**PLANNING COMMISSION ACTION AGENDA ITEM**

Tom Bromley, representing Allied Activities, has submitted a plat alteration request for the preliminary plat of Kingview No. 7. The request pertains to the following items:

# Plat Alteration - Kingview No. 7

*PRELIMINARY PLAT OF*  
**KINGVIEW ADDITION NO. 7**  
 LOCATED IN A PORTION OF SECTION 5, TOWNSHIP 9 NORTH, RANGE 28 EAST, W.M.  
 CITY OF WEST RICHLAND, BENTON COUNTY, WASHINGTON

**EXHIBIT A  
REVISED PHASING PLAN**

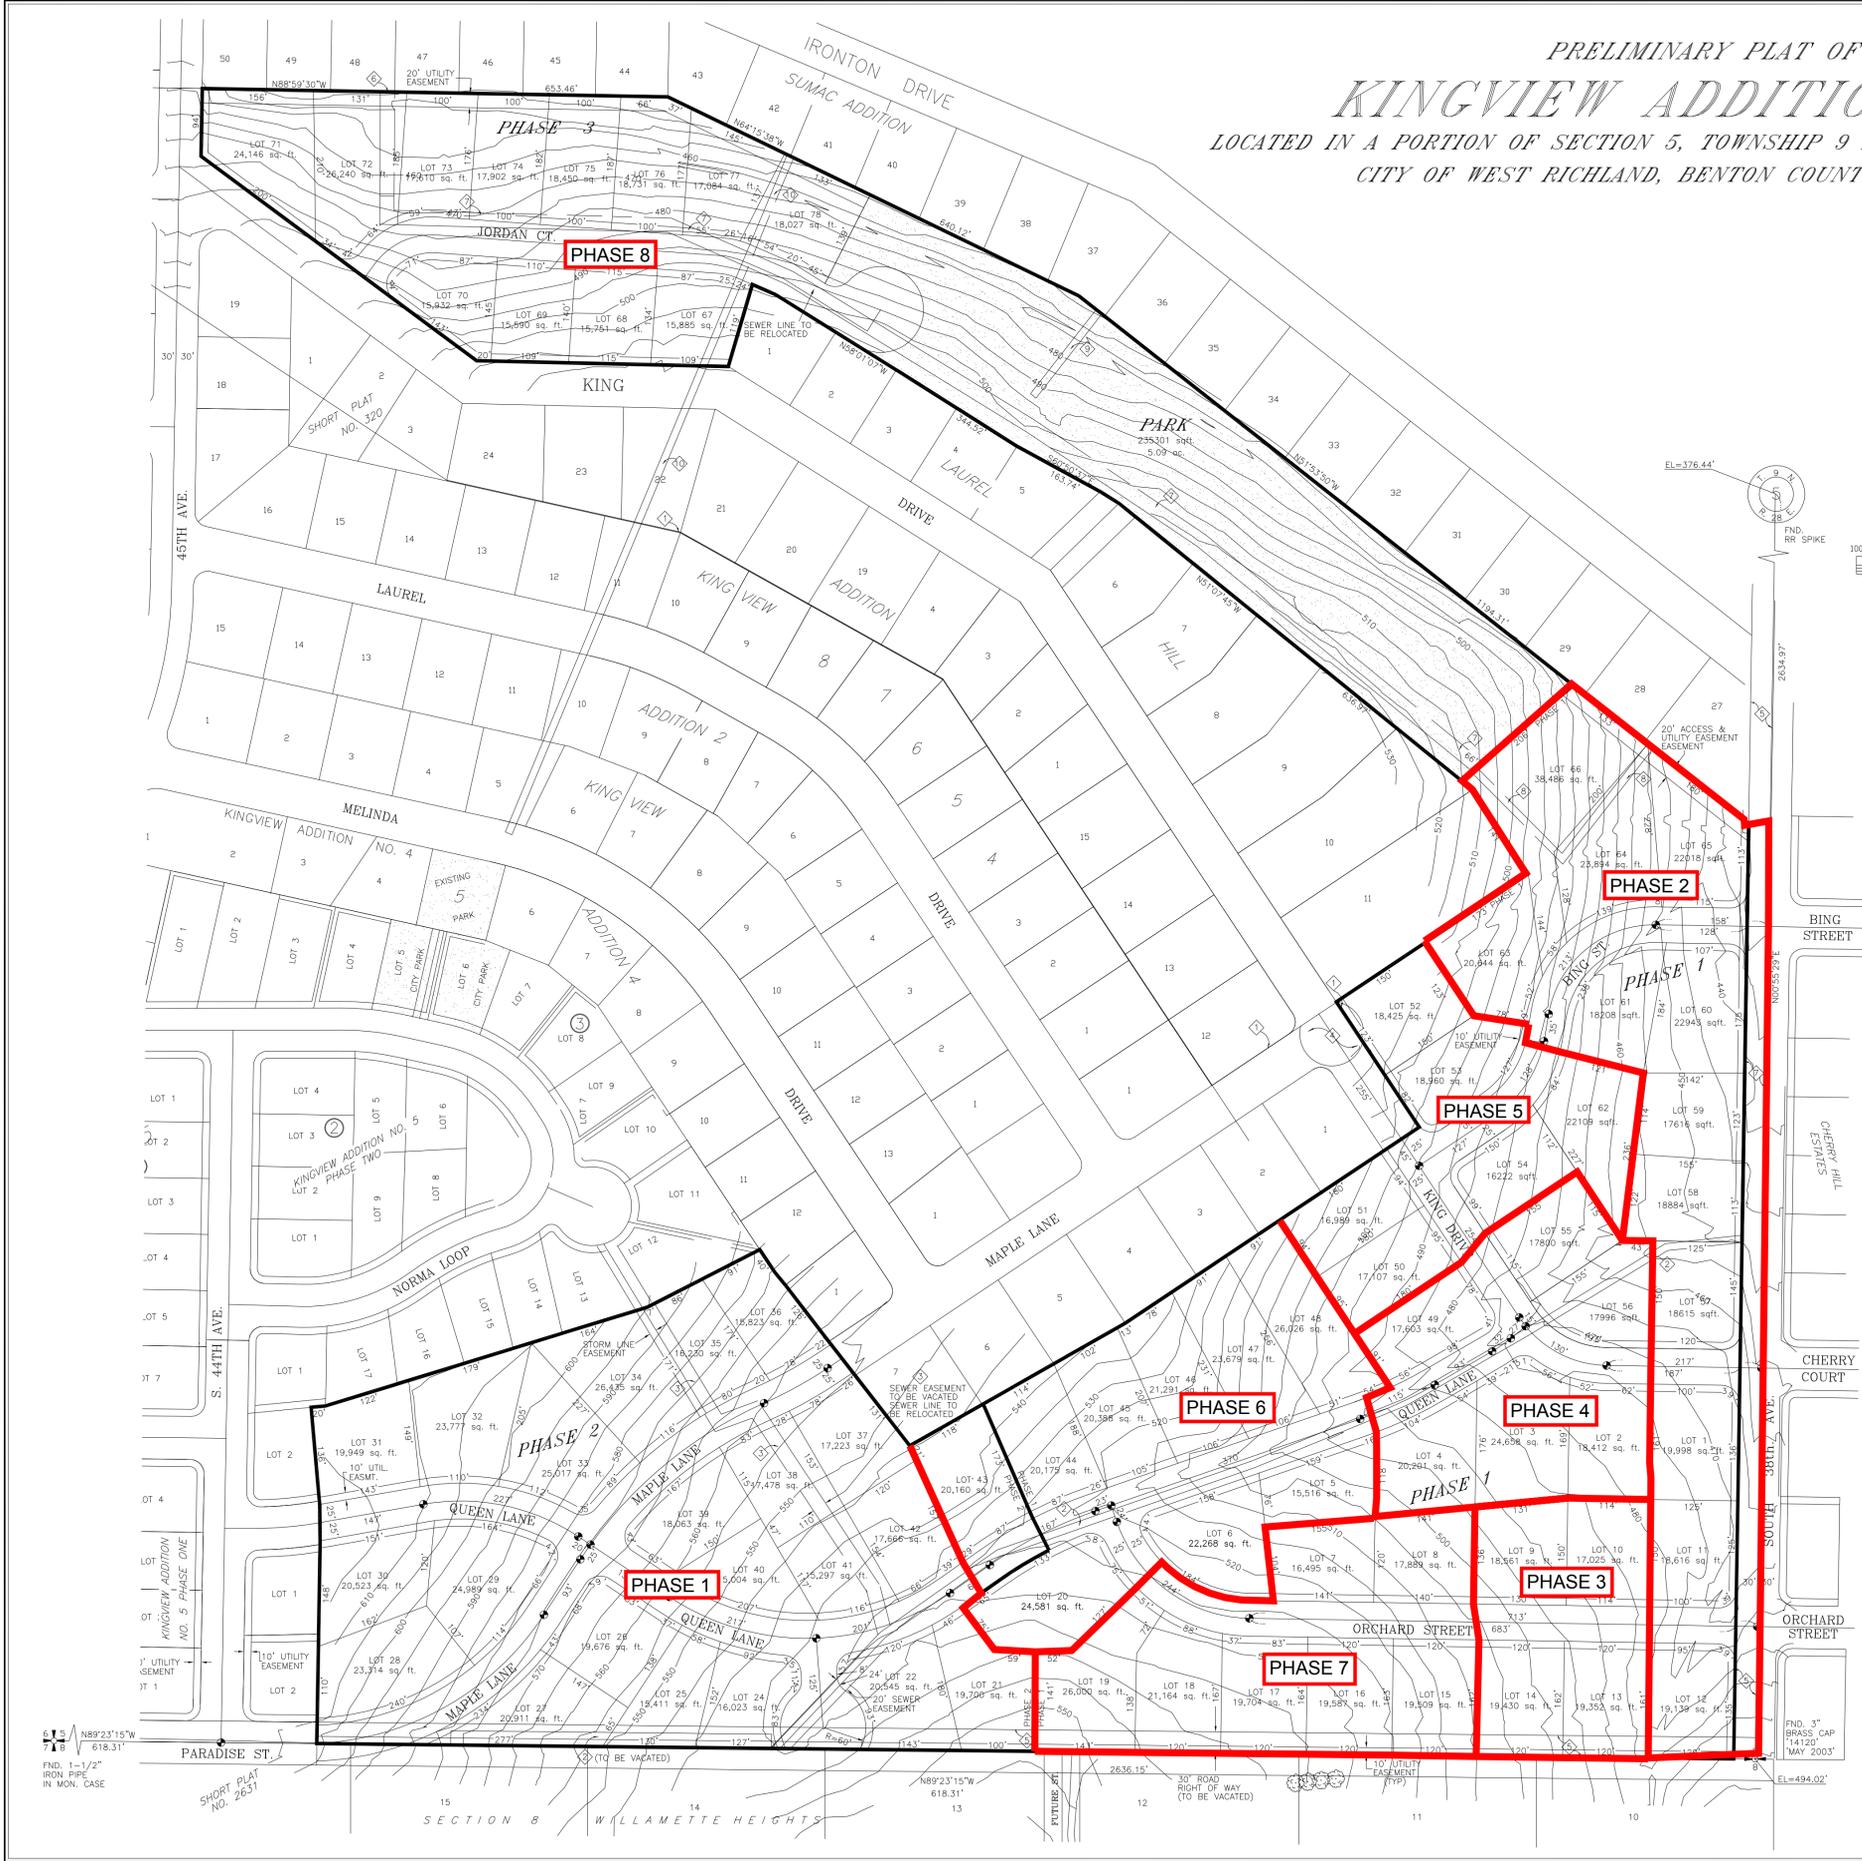
Revised Phasing to allow flexibility in size and sequencing. Phase 1 proposed to be where Phase 2 was shown on the approved preliminary plat.

1. Revise the phasing of the plat from 3 phases to 8.

*The original preliminary plat showed the subdivision being built in three large phases. The proposal is to change the phasing to show eight smaller phases instead, allowing for more flexibility in construction. Staff sees no issues with this and recommends approval. The new phasing plan is shown on **Exhibit 2**.*

PROPOSED AMENDMENT TO ADOPTED AUGUST 7, 2012 PLAN

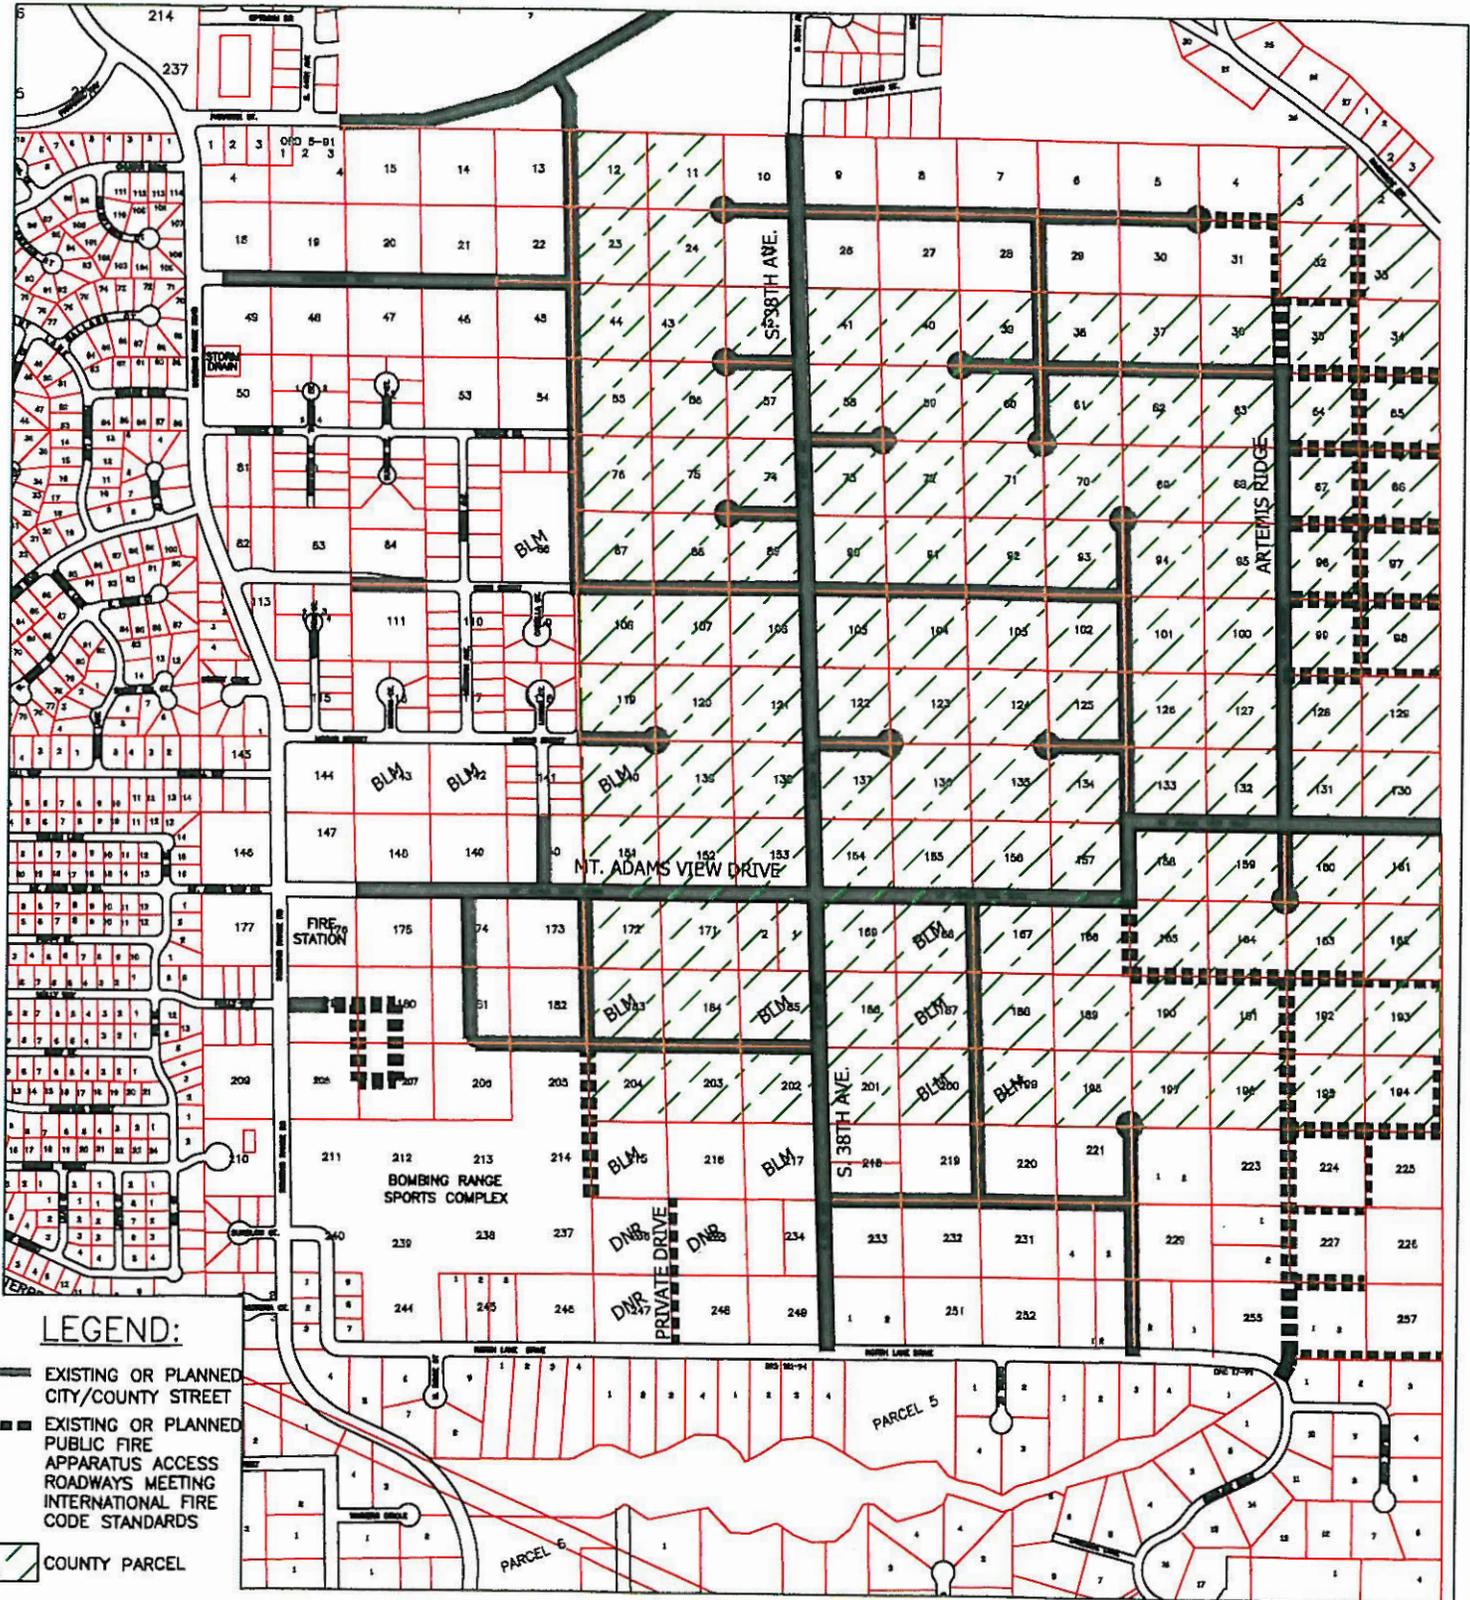
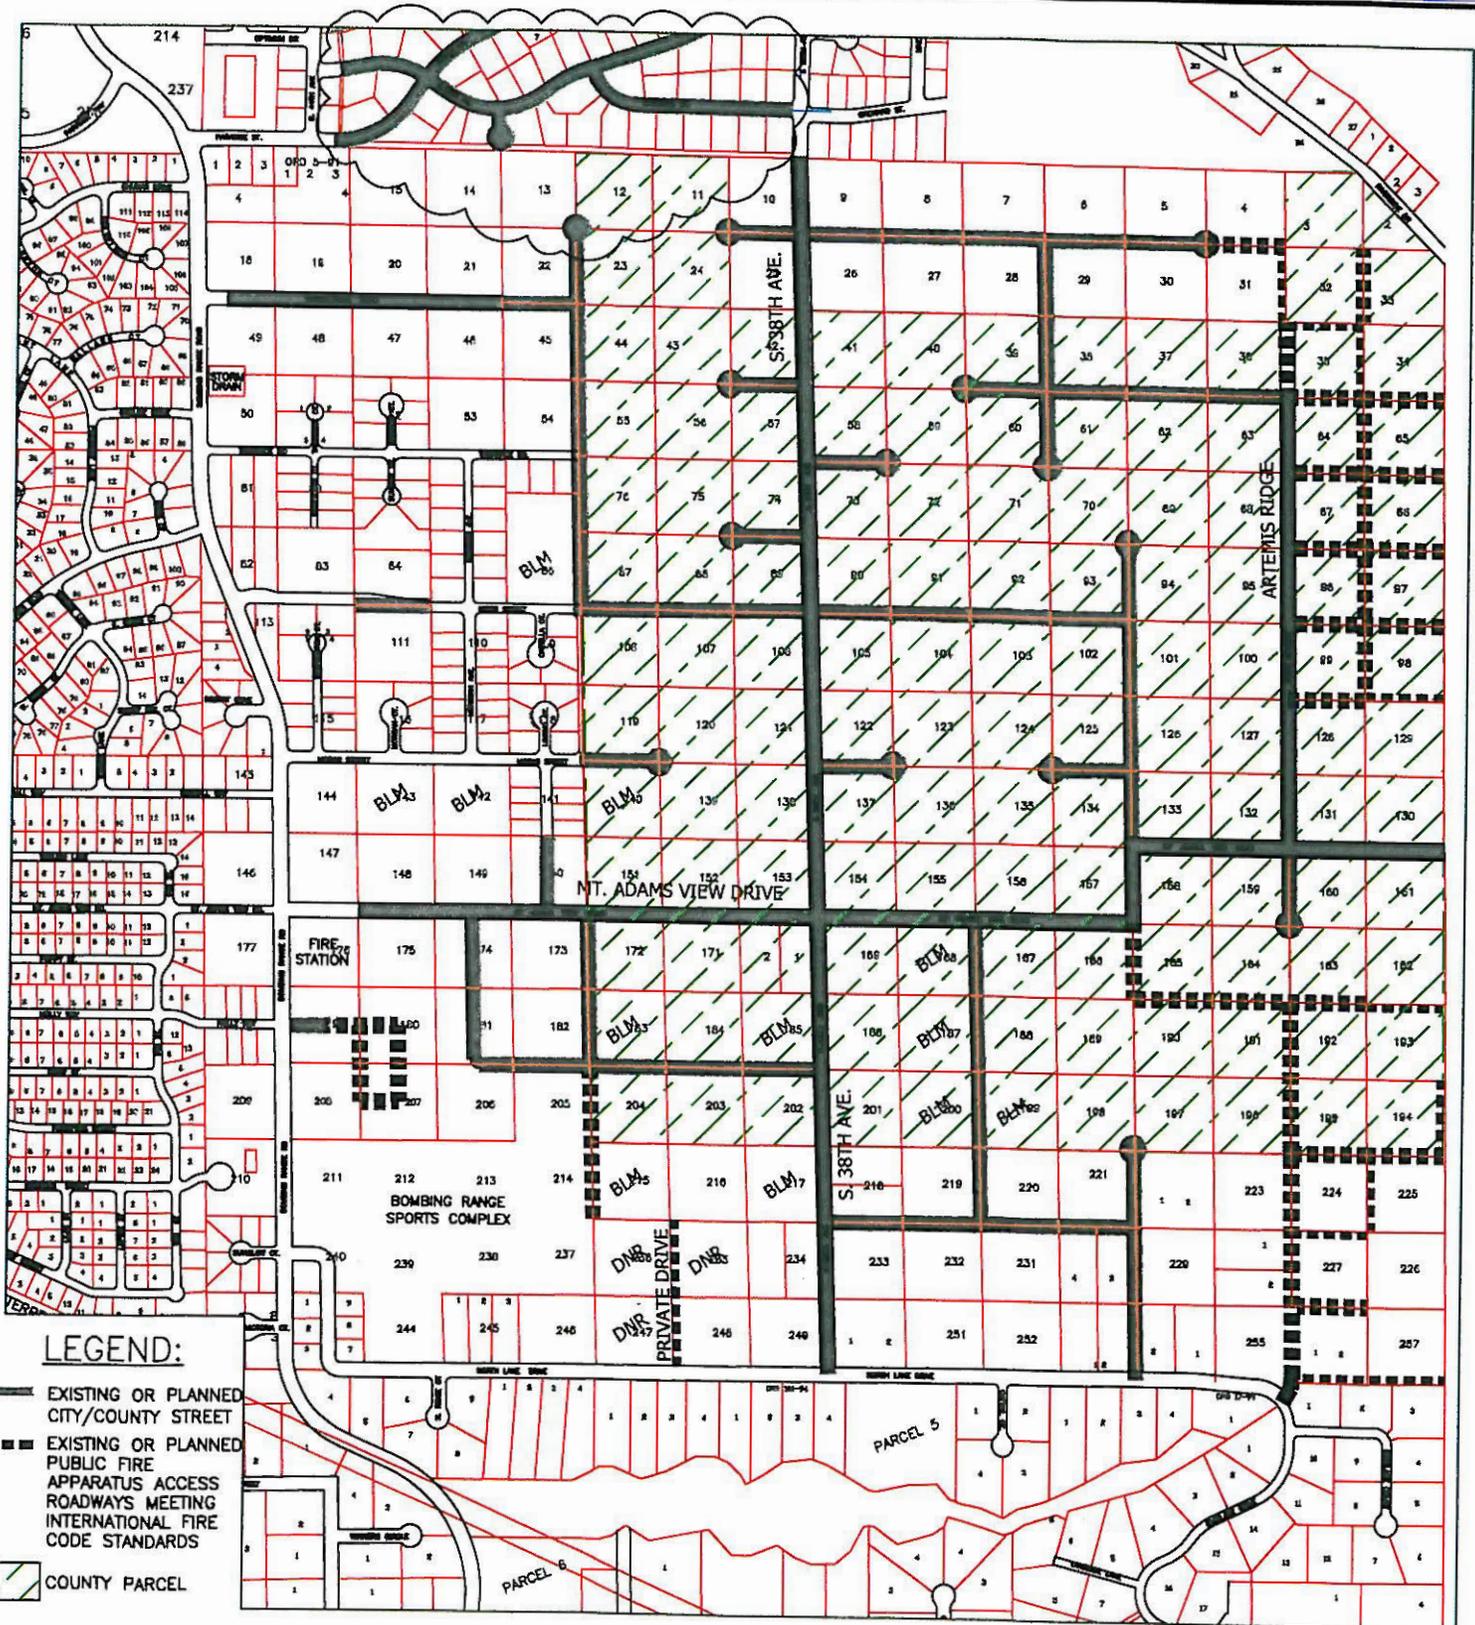
- The existing Section 8 Roadway Plan, which is the recommended road development pattern for the section of houses to the south of this property, currently shows a future through-street connecting Section 8 with this plat. The original Roadway Plan did not have access to this preliminary plat, and therefore had to make a best guess as to how the adjacent Section 8 properties would tie in. After overlaying this plat and looking the connectivity with Section 8, Staff has recommended that the Roadway Plan be amended. This proposal and more in-depth information is shown in **Exhibit 4**.

The proposed amendment to the Section 8 Local Roadway Plan would eliminate the north/south planned roadway between Lots 12 and 13.

# Paradise St. Readdressing

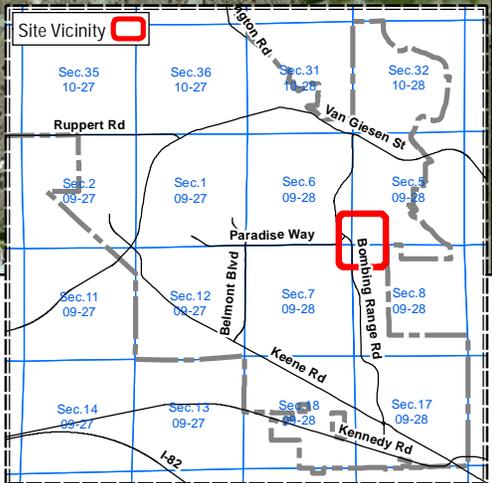
- The existing homes along Paradise St. will need to be readdressed prior to completion of the first phase of construction. The homes will receive new address numbers, and the road name will change to Maple St. Staff has conversed with Benton County Emergency Services on this matter, and it is also their recommended best course of action. See communication from BCES and map of affected properties in **Exhibit 5**.

I observed in the plat map that Maple LN will be "flowing into" what is now Paradise ST in a way the suggests that all are one continuous street. In other words, one does not (traveling eastbound) make any turns to leave Paradise ST and then travel on Maple LN. Such transitions with a name change are not unprecedented, but should be avoided. This is especially true when only the single block of Paradise ST is affected. It simply doesn't make sense to change the name (as one travels along the route) for just one block.
